## COMPLETION REPORT FOR PHASE 1 INTERIM ACTION AT THE FORMER SATRALLOY SITE

Mingo Junction, Ohio

**Prepared By:** Golder Associates Inc.  
18300 NE Union Hill Road, Suite 200  
Redmond, WA 98052 USA

December 14, 2017

Attachment: Drawing IAR-520

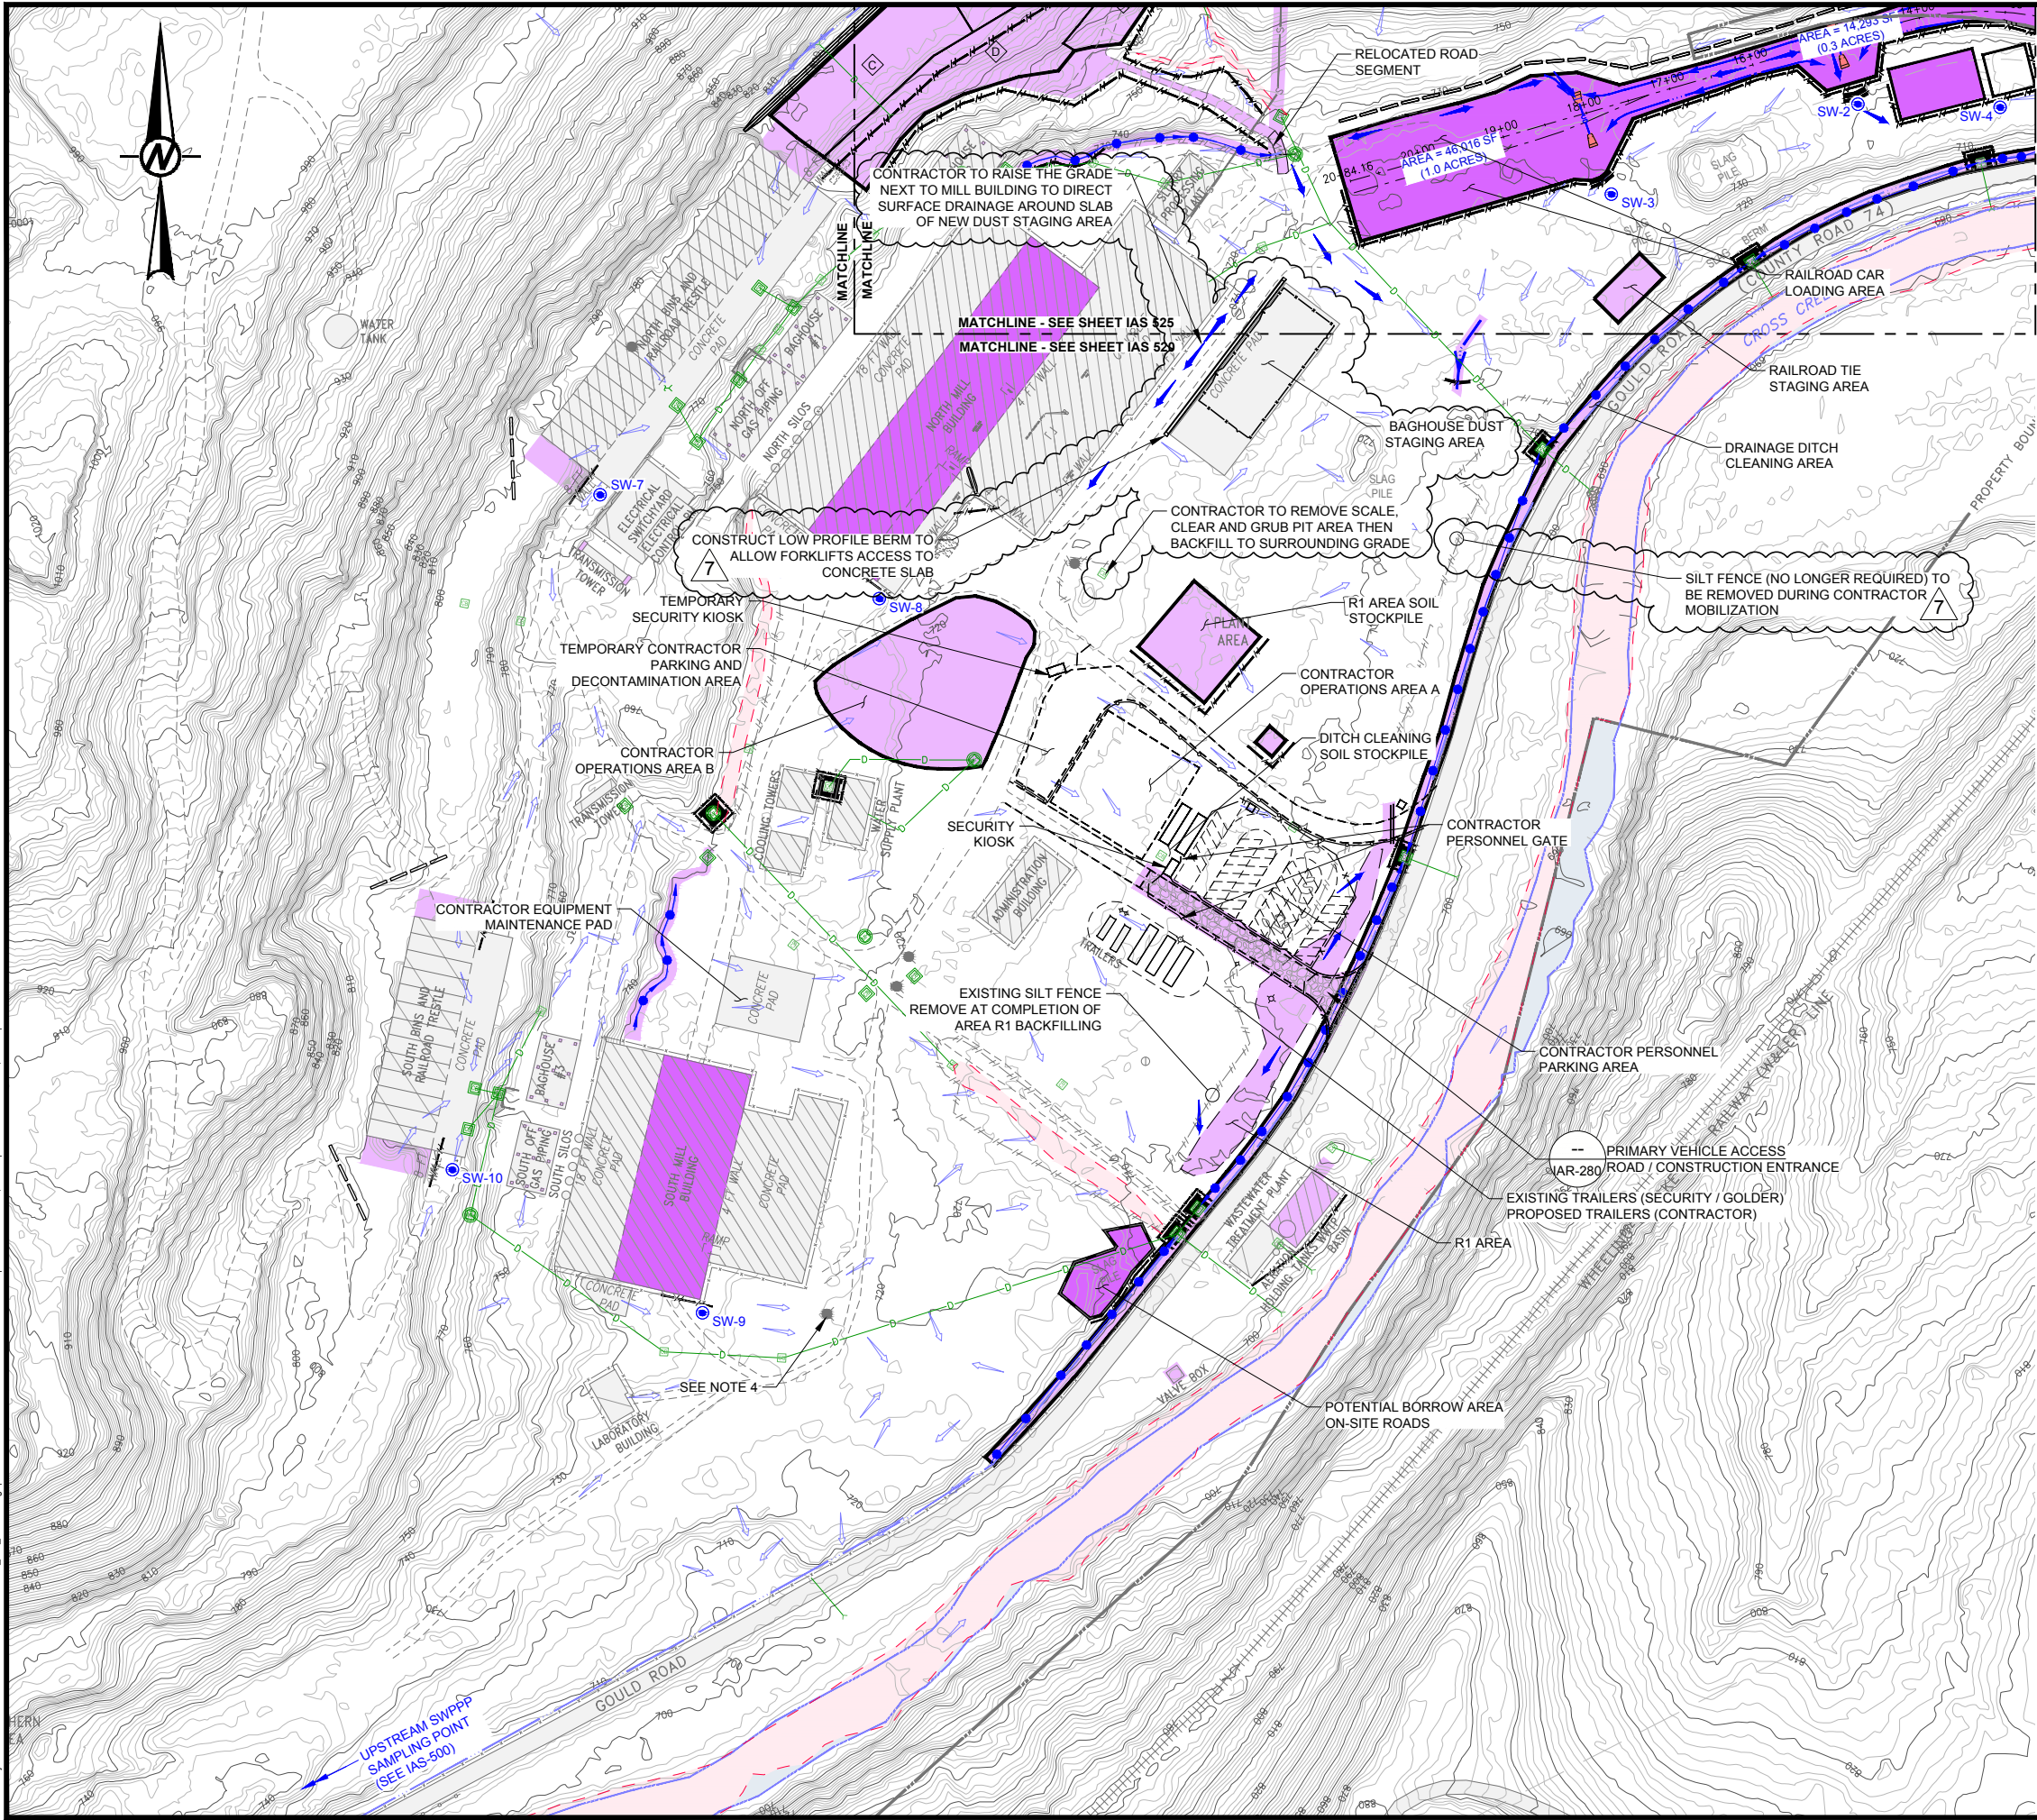
The proposed change is shown on the attached revised drawing IAR-520.
